ODS KIT S-O HARDWOOD FASCIA

NEWMAR CORP P.O. Box 30, Nappanee, IN. 46550 UNITS: INCHES TITLE BLOCK: 80D	Model:	Sheet	Drawn by:	Checked by:	Revision:	By:
	CSFD 3947	1 OF 2	J. M.	D. E.	CHANGED FASCIA PART # TO 166903 ILO 166456; CHANGED HEIGHT OF FASCIA TO 7 1/8" ILO 6 1/2";	J. M.
	Title:	I.D. # 2024\CA\CAB\FASCIA\CS3947	Date:	Date:	CHANGED RETURN LEG HEIGHT TO 70 7/8" ILO 77 3/8" & UPDATED END CAP DEPTH; (2024 ECO #85)	Date:DE 4/12/23
	FASCIA		8/30/22	10/7/22	Revision: ADDED NEW PART # 166456 ILO 161750 DUE TO CHANGES MADE FROM	By: J. M.
					PCR #240410 (2024 ECO #30)	Date:DE 2/2/23

BEDROOM S-O HARDWOOD FASCIA

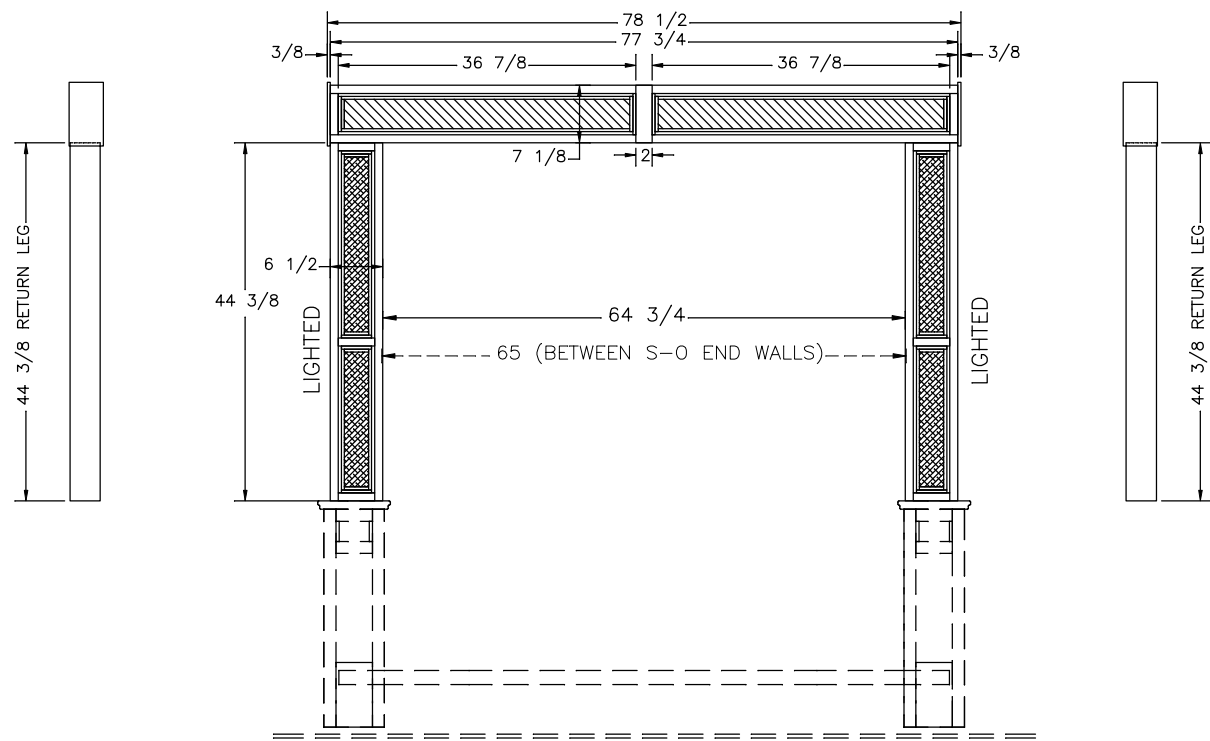
NEWMAR CORP P.O. Box 30, Nappanee, IN. 46550 UNITS: INCHES TITLE BLOCK: 80D	Model:	Sheet	Drawn by:	Checked by:	Revision: CHANGED FASCIA PART # TO 166903 ILO 166456; CHANGED HEIGHT OF FASCIA TO 7 1/8" ILO 6 1/2";	By: J. M.
		CSFD 3947	J. M.	D. E.	CHANGED RETURN LEG HEIGHT TO 44 3/8 ILO 50 7/8" & UPDATED DEPTH OF END CAP (2024 ECO #85)	Date:DE 4/12/23
	Title:	I.D. # 2024\CA\CAB\FASCIA\CS3947	Date:	Date:	Revision: ADDED NEW PART # 166456 ILO 161750 DUE TO CHANGES MADE FROM	By: D. E.
		FASCIA	8/30/22	10/7/22	PCR #240410 (2024 ECO #30)	Date:DE 2/2/23
